**Re: Haldimand County Hydro Inc. (EB-2013-0134)
2014 Cost of Service Electricity Distribution Rate Application
Responses to Interrogatories**

**Haldimand County Hydro Inc. (“HCHI”)
EB-2013-0134
INTERROGATORY RESPONSES**

Diagram 1

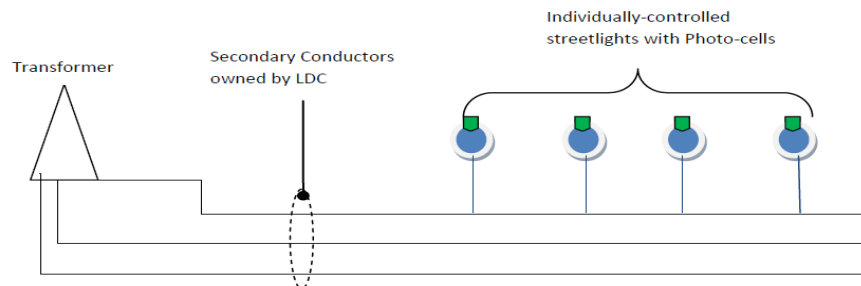
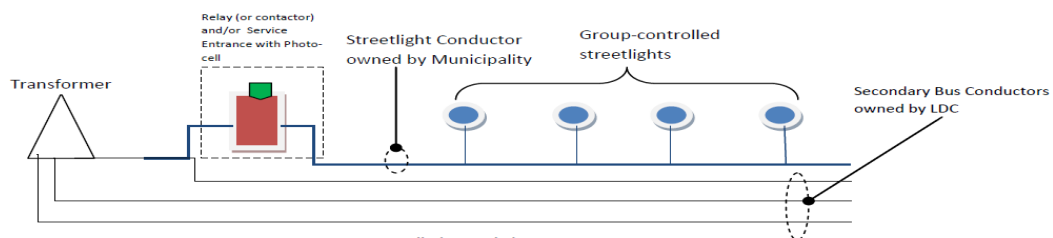
On Sheet I6.2 for street lighting, there are 2,979 Devices and 1,469 connections. This suggests that one connection serves two devices. If this observation of 2:1 fixture: connection ratio is incorrect please explain the wiring configurations and how they relate to the factors.

Generally the rural area streetlights are connected in the configuration of Diagram 1. The urban areas have streetlights connected in the configuration of Diagram 2.

HCHI reported in its 2010 Cost of Service Electricity Distribution Rate application 2,879 Fixtures and 1,610 Connections (1.8:1 ratio). The average connection ratio identified on Sheet I6.2 is correct at 2:1.
